Technical Memorandum: Review of the Indirect Impacts of the Wetland Permit Application, Back Forty Project

Technical Memorandum

Review of the Indirect Impacts of the Wetland Permit Application Back Forty Project

January 19, 2018

Figure 1: Western portion of the Joint Permit Application Figure 3-1 showing wetland impacts.

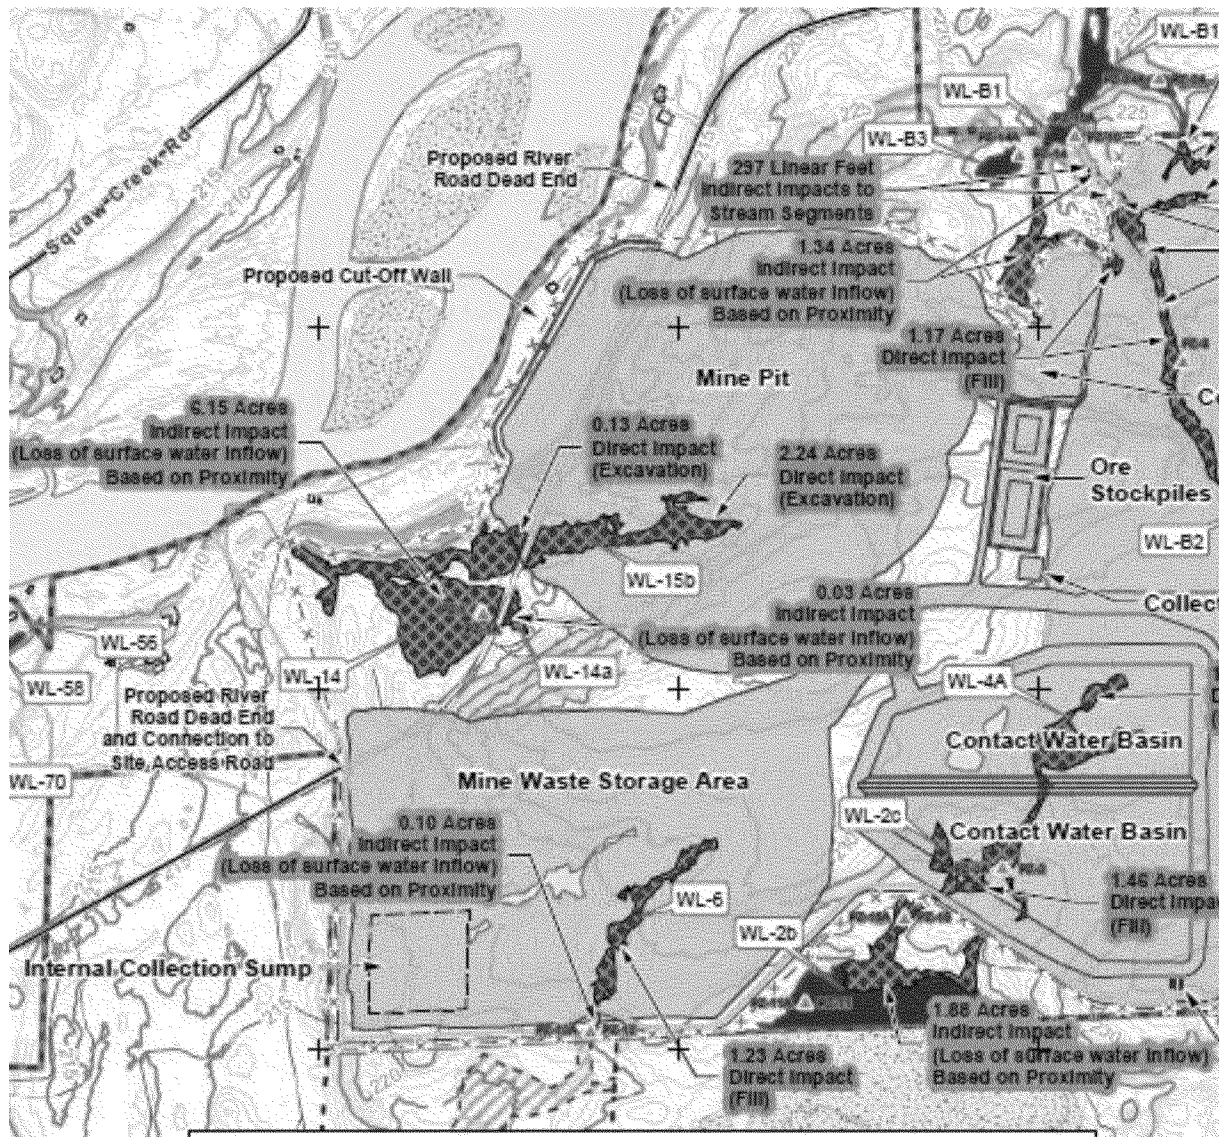
The JPA states the project would directly impact approximately 11.22 acres of wetlands by excavating about 5.31 acres and placing fill on about 5.91 acres (JPA, p 2 of 15). It also states the project would indirectly impact approximately 17.17 acres of wetland, of which 4.16 acres is emergent and 13.01 acres is forested (Id.). The JPA has numerous tables and figures attached supporting aspects of the application. JPA Figure 3-1 shows areas of direct and indirect wetland impacts. Figure 1 shows six areas of indirect impacts, with the largest on the west being for 6.15 acres due to “loss of surface water inflow”, presumably from pit excavation intercepting

the stream. The others are also due to a “loss of surface water impacts. Figure 2 shows the east side of JPA Figure 3-1 which shows several indirect impact areas of loss of surface water flow due to water balance model.

*Figure 3: Snapshot of Foth (2017) Figure * showing boundary conditions in layer 1. The blue is river boundaries, both on south and east boundary and internal to the model. The green represents wetlands, also simulated using the river package.*

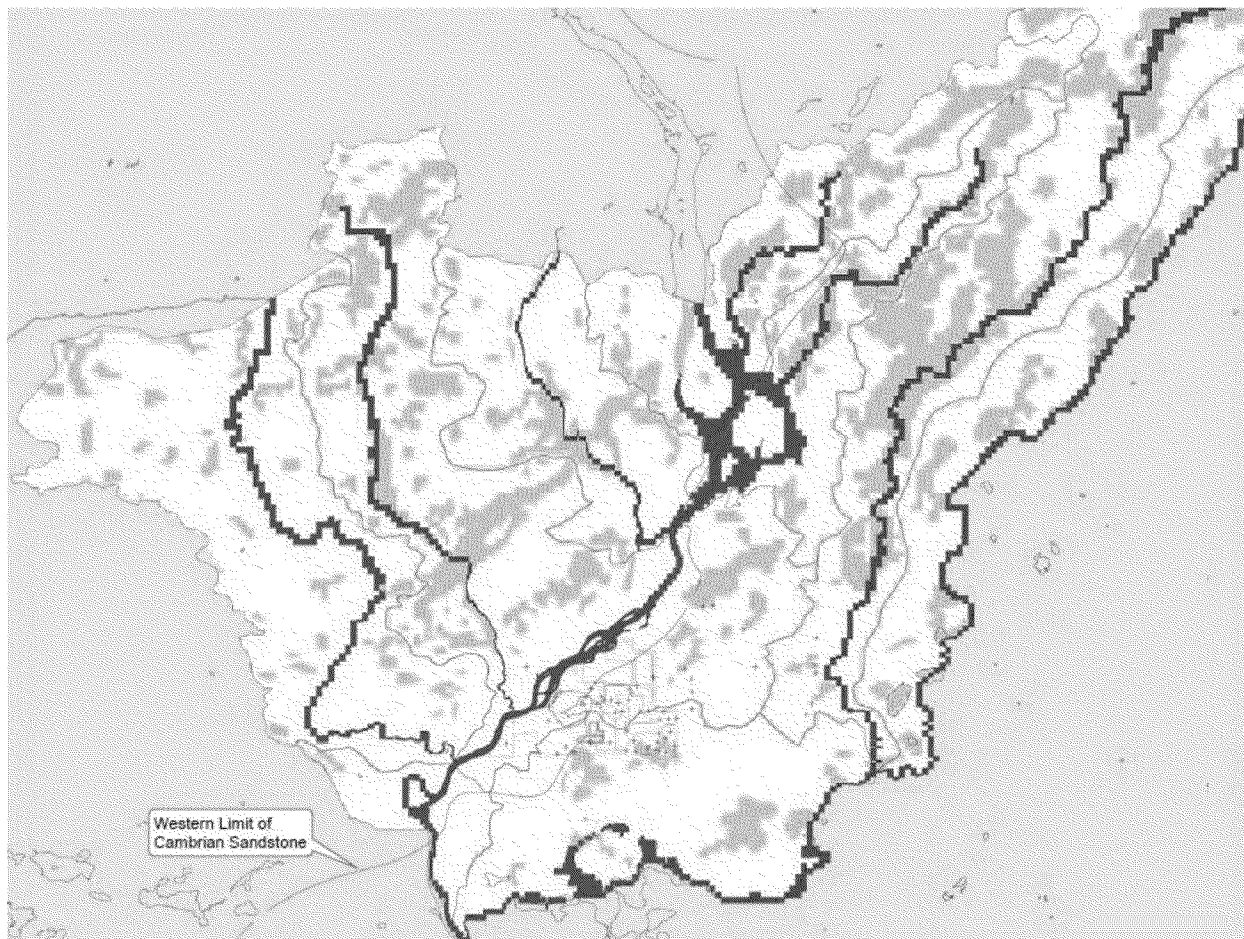
Figure 3 shows boundary conditions in layer 1. The green areas are River boundaries used to simulate wetlands. I verified that the model does not include recharge, a specified flux into the model domain, in the wetlands, so the method prescribed for simulating flow from the wetlands would simulate recharge from them. Recharge would occur only if the water level falls below the specified bottom of the River boundary. The total discharge is 56,119 m³/d to reach 11 (based on analysis using GWVistas), the River boundary reach simulating wetlands.

Perusal of the boundary using GWVistas shows a mixture of positive and negative flows to different model cells.

Figure 4: Water balance for the pit. GW inflow is the net of flows recorded as in and out from the east, west, north and south directions.

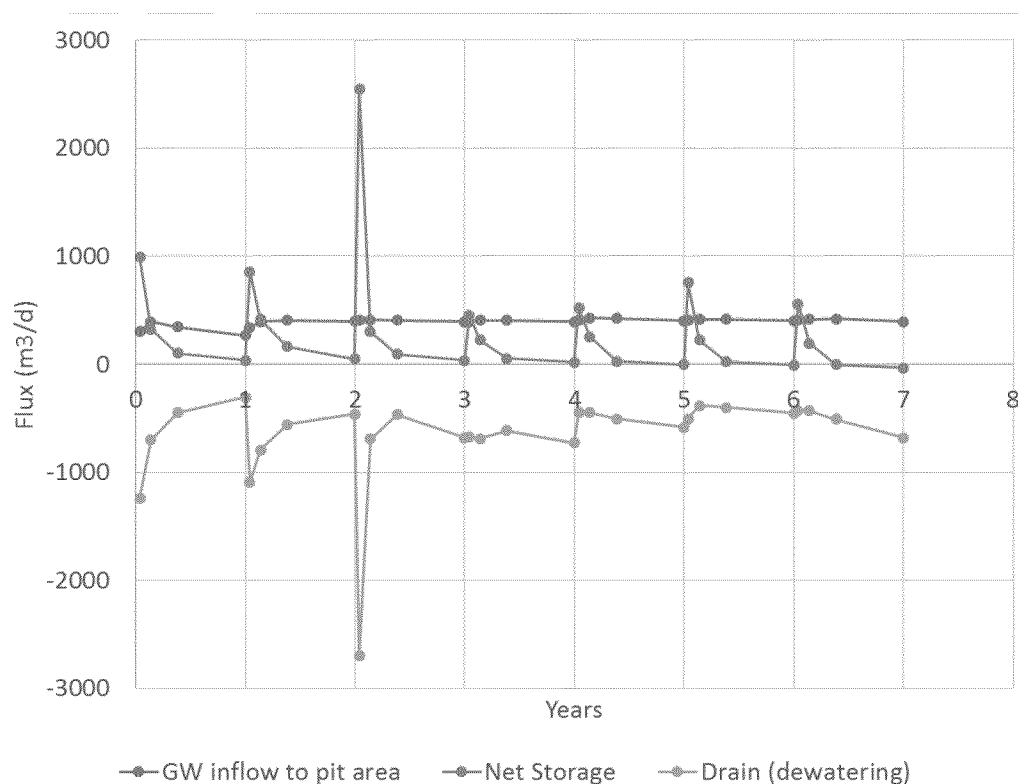
Changing the analysis to 20 time-steps provided an understanding of how the model handles fluxes near the pit. Figure 4 is the water balance for all seven layers for a polygon drawn within the GWVistas framework on the pit boundary. The end of period mass balance values are very similar to those determined for Foth's model runs. Figure 4 shows that dewatering equals a combination of water released from storage and groundwater inflow to the pit area. At the beginning of each stress period, the rate of flux released from storage would peak and then settle to close to zero by the end of the period. The peak in storage release is due to the step lowering of the DRAIN water level as described above. The inflow to the area from all directions was relatively constant through time. Analysis of the mass balance by layer shows that the inflow to the pit area and the level from which the DRAIN removes water becomes deeper with years, as would be expected.

Figure 5: Screen capture of layer 1, steady state groundwater contours. The green areas are RIVER boundaries. The pit is outlined in green near the portion of the river with islands.

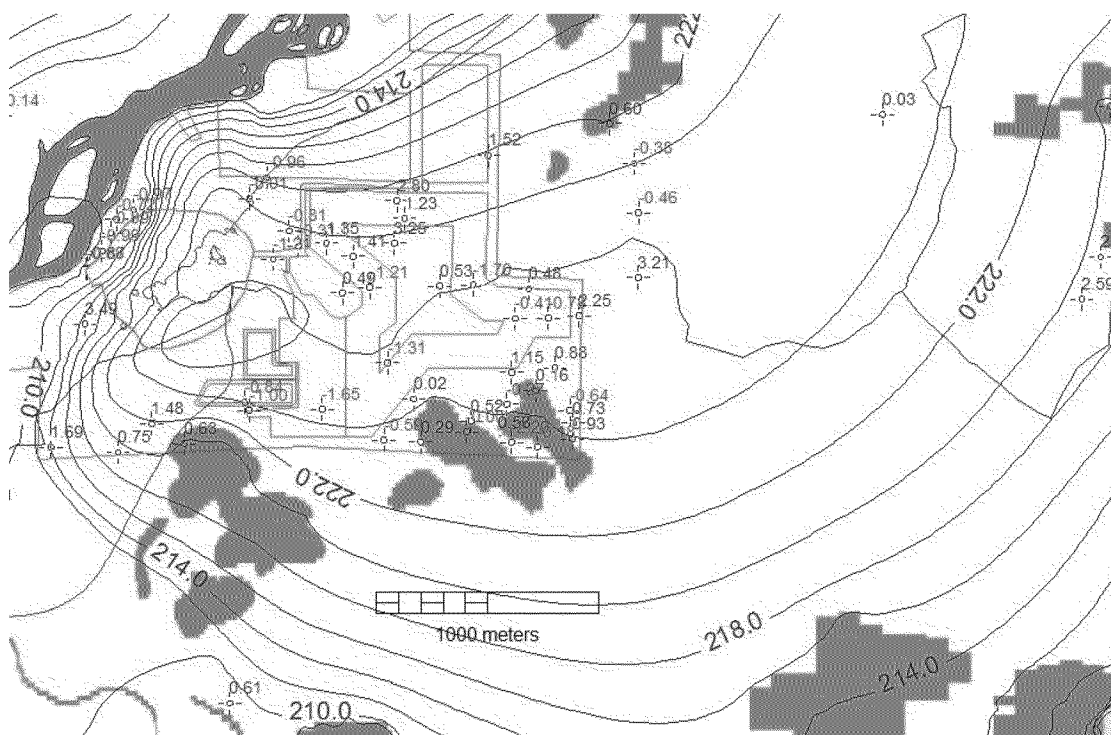
The RIVER boundaries as used for wetlands on the site limit the drawdown around the site. Steady state or pre-development groundwater contours form a groundwater ridge just south of

the proposed pit (Figure 5 and Figure 2-7 in Foth 2017). RIVER boundaries yield water to the aquifer based on the gradient between the water level in the wetland and the water table and conductance of the boundary. As dewatering lowers the water table, the gradient increases so discharge through the bottom of the boundary also increases. If the water table lowers sufficiently that there is a disconnect between the boundary (the bottom of the wetland) and the water table, the gradient becomes 1. Foth (2017) described that the flow at this point would equal the recharge as simulated around the model domain.

Figure 6: Screen capture of layer 1, end period 7, show drawdown contours. Green is RIVER boundaries representing wetland, yellow is DRAIN boundaries at the pit and purple areas are dry cells.

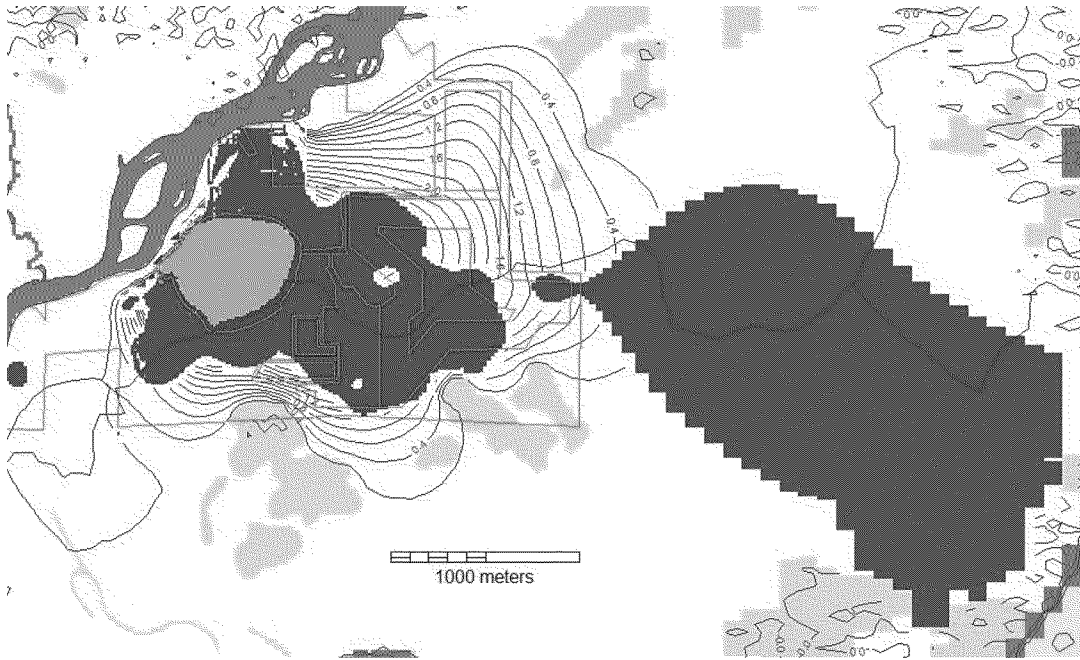
Drawdown contours curve around the wetlands, a result of the boundary discharging water to the groundwater table (Figure 6). The wetlands along the south part of the drawdown (Figure 6) somewhat limit the southward expansion of the drawdown cone. Wetlands northeast of the project site also limit the expansion. The influence of the wetlands extends into deeper layers. Drawdown in layer 2 is similar to that in layer 1, except for the dry areas (Figure 7).

Figure 8: Detailed drawdown around a specific wetland area, WL-2b. Layer 1 at the end of year 7. The brown is the wetland over which a detailed water balance will be determined.

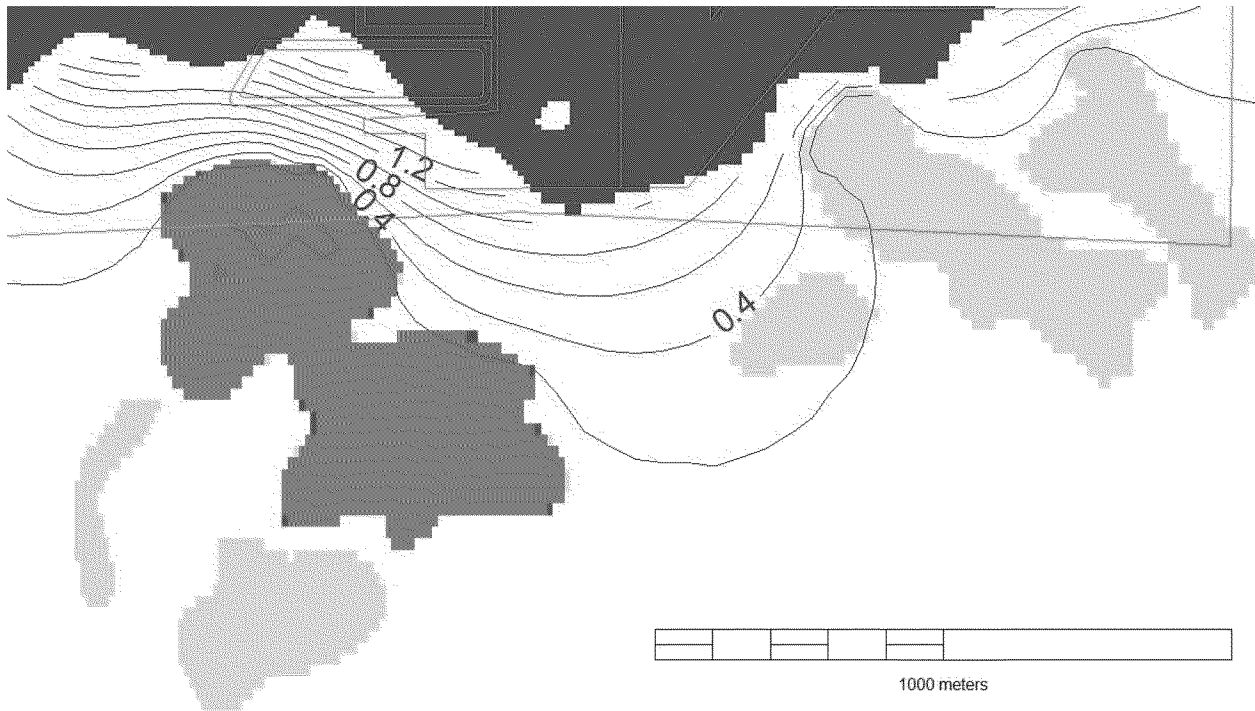
To consider the effect that wetlands have in maintaining the groundwater level, I considered one wetland area just south of the project site as outlined in Figure 8. That figure shows the drawdown contours bending around the wetland area. Drawdown within the wetland is near zero. Using the GWVistas mass balance function, I determined the water balance hydrographs for the seven-year dewatering period (Figure 9). Storage changes are tiny because there is no drawdown within the area. Inflow net is the sum of groundwater flux into the area from all directions and all layers. River in and river out are fluxes into and out of the model water balance. The difference is approximately the inflow net to the area. That River out is a substantial flux shows that there is a significant interchange of surface and groundwater in the model in this area, and presumably other River boundaries that represent wetlands. The RIVER boundary therefore maintains the groundwater level. I also considered flux from individual cells, and some had flux rates as high as the equivalent of between 6 and 7 in/y, the recharge rate, as indicated by Foth (2017).

Figure 9: Water balance for the polygon region in Figure *, with fluxes recorded for the end of the year.

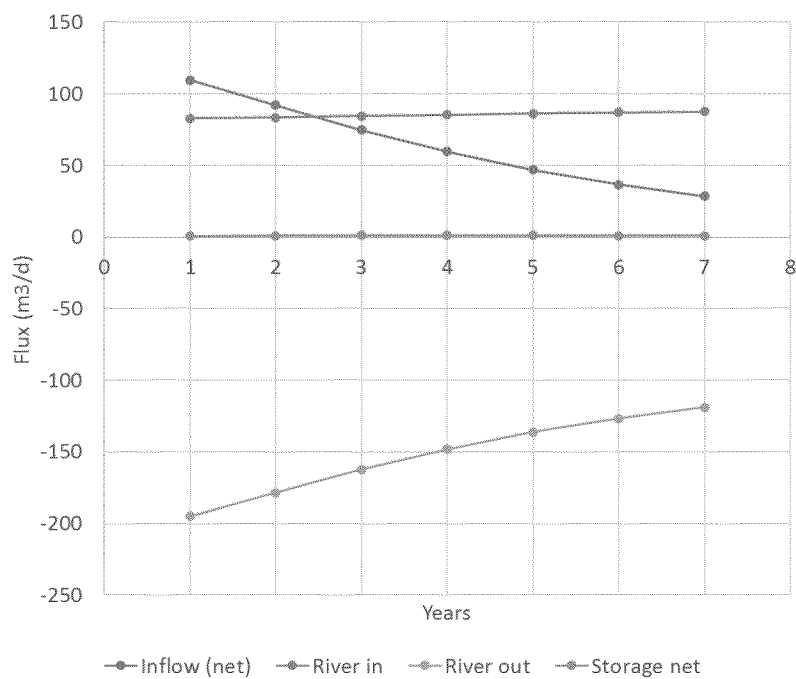
The conceptual model of the hydraulic connection between wetlands and groundwater is wrong. As described, RIVER boundaries, as used to simulate wetlands, can provide up to the full recharge rate, based on the conductance being set so that at a 1:1 gradient the flux would equal recharge. This presumes the conductivity through the bottom of the wetland is similar to the conductivity within the upper layer of the alluvial formation. At the wetland in Figure 8, horizontal and vertical conductivity equals 1.49 and 0.2 m/d, respectively, which is similar to the $K=1$ m/d used to estimate conductance in the RIVER boundary package (as determined from the GWVistas model file). Setting conductivity equal to that in the surface soil layer ignores the sediment that would accumulate at the bottom of a wetland which would likely form a skin on the bottom of the wetland that would impede seepage into the groundwater.

Without the seepage from the wetland, drawdown would expand further and increase the amount of indirect impacts to the wetlands.

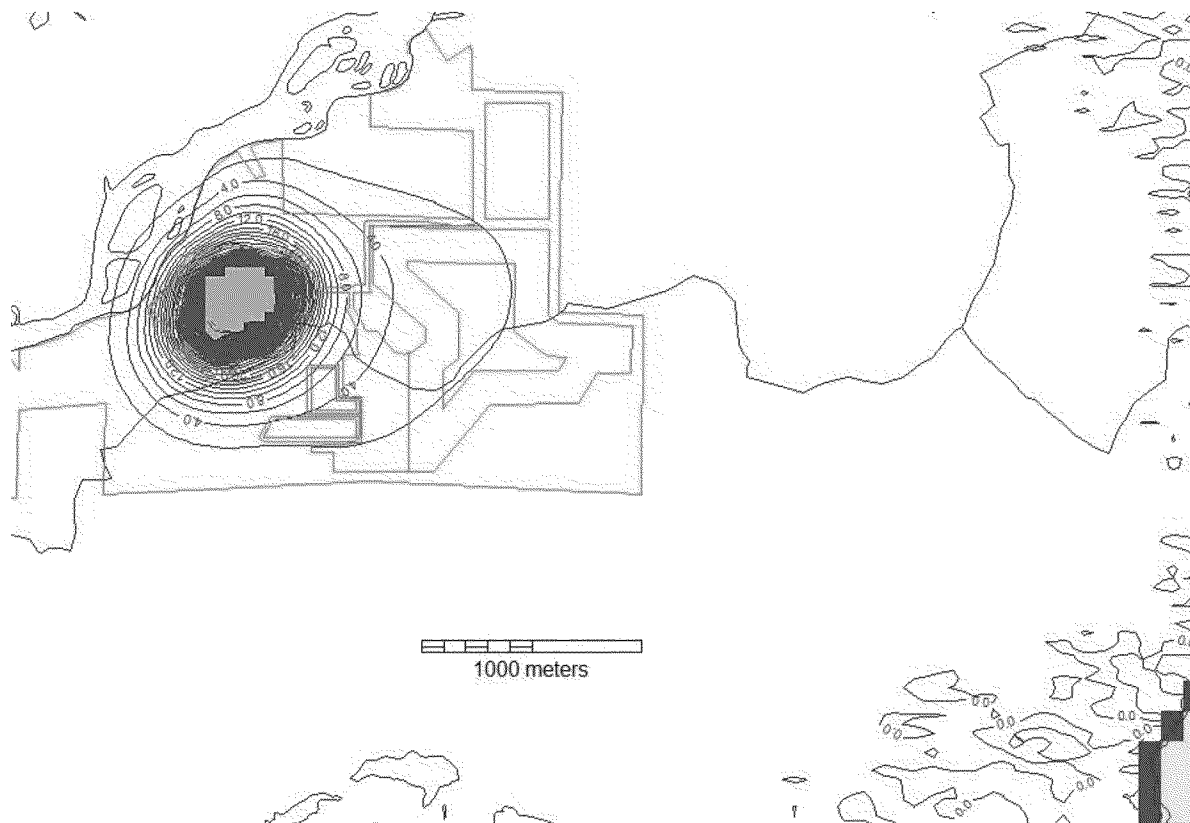
At depth, in layer 6, drawdown is more elliptical because at this point the dewatering DRAINS are drawing from the bedrock. In fact, by year 7, most dewatering is from the bedrock, which has a very low conductivity. The low conductivity leads to very steep water table and limits the extent of drawdown at depth. In layers 5, 6, and 7, the conductivity is less than 4×10^{-2} m/d. The river also apparently limits the drawdown extension to the west.
